DEC 19 1996
 PSI DWG # V049-8-152
 L1G0-D961592-E-V

| D103236 | DO NOT SCALE DRAWING | ENGINEER ZH | 1-24-96 | TITLE OUTER BEAM G44 |
| USED ON | CADD FILE NAME | B103248E | | B DWG. NO. 103248 SCALE: NONE SHEET 1 OF 1 |

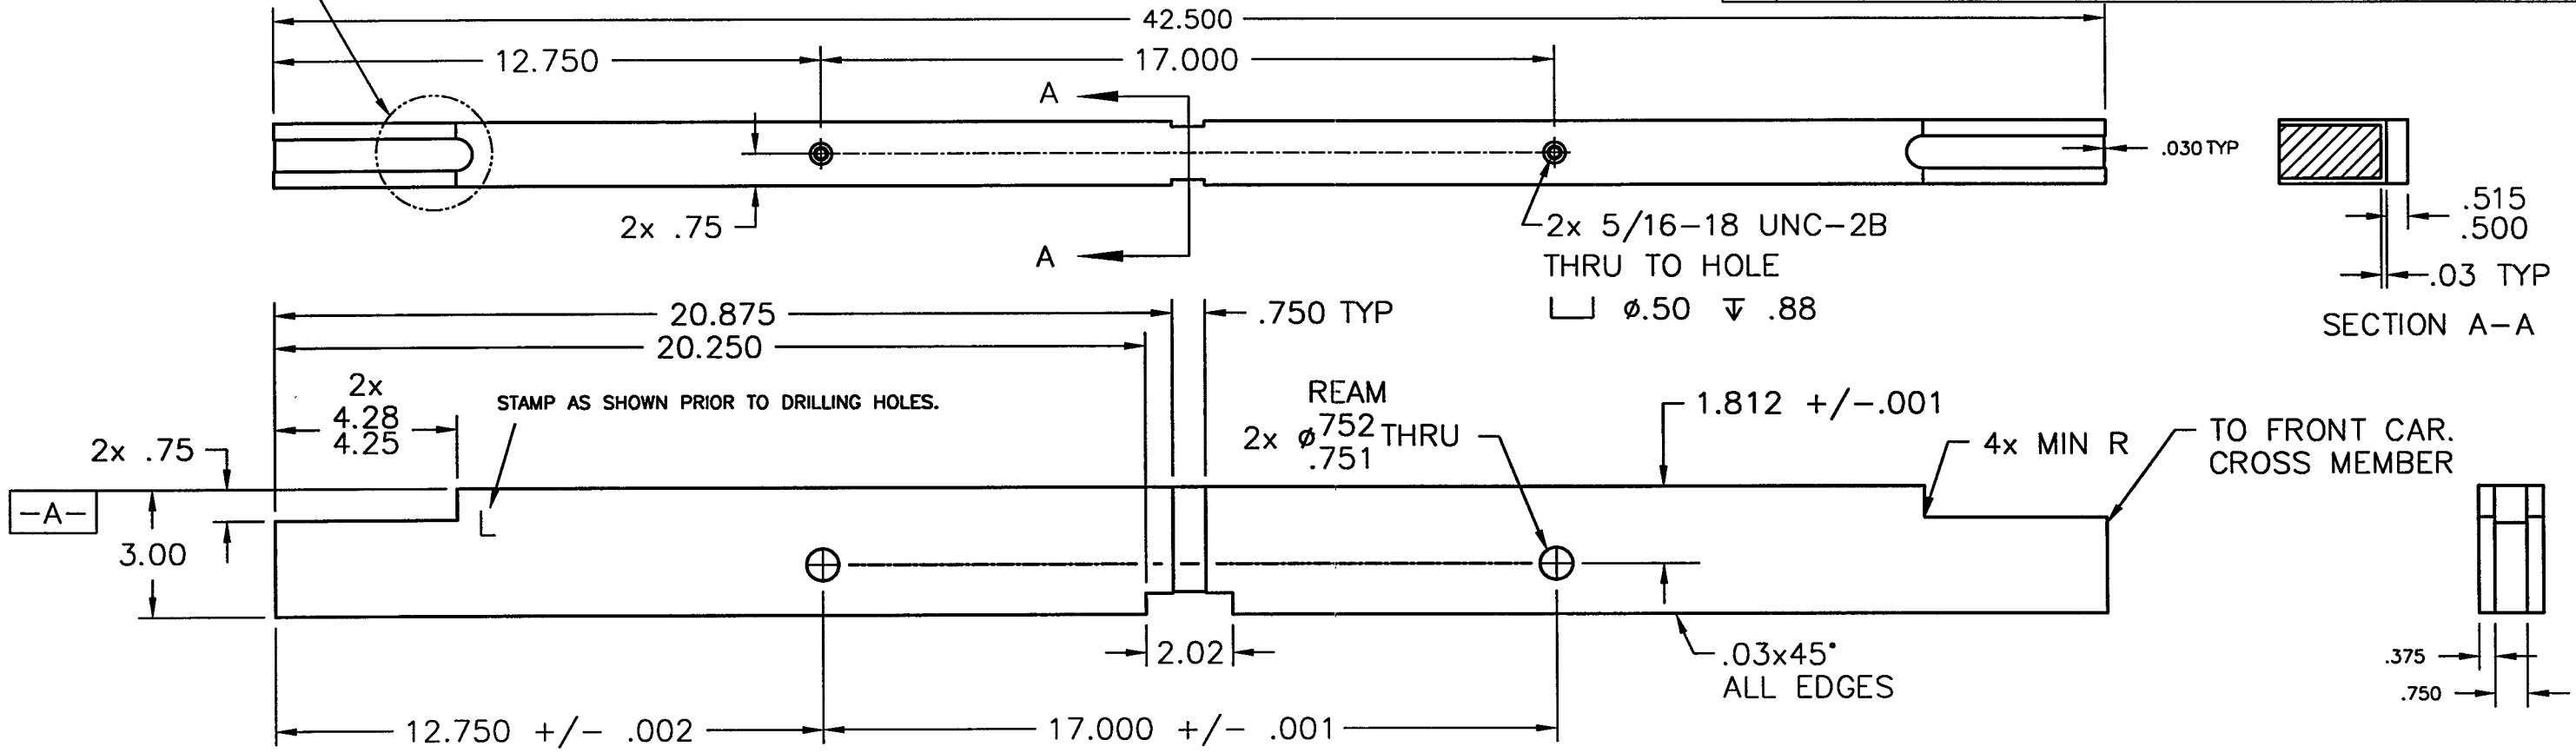
| REVISIONS | | | |
|-----------|--|----------|----------|
| B | REMOVE No.4 FINISH, 5/16-18 WAS 1/4-20 | | 2-8-96 |
| C | DELETED TWO HOLES; .03 WAS .13; ADDED +/- .001 TOLERANCE TO 1.812 DIM; REAM .752/.751 WAS .761/.751; ADDED 12.750 +/- .002 DIM; ADDED 17.000 +/- .001 DIM.; ADDED STAMPING INSTRUCTION; ADDED NOTE 4. 42.500 WAS 42.50 | AJL | 7-15-96 |
| E | CHANGED TITLE | AJL | 10-28-96 |
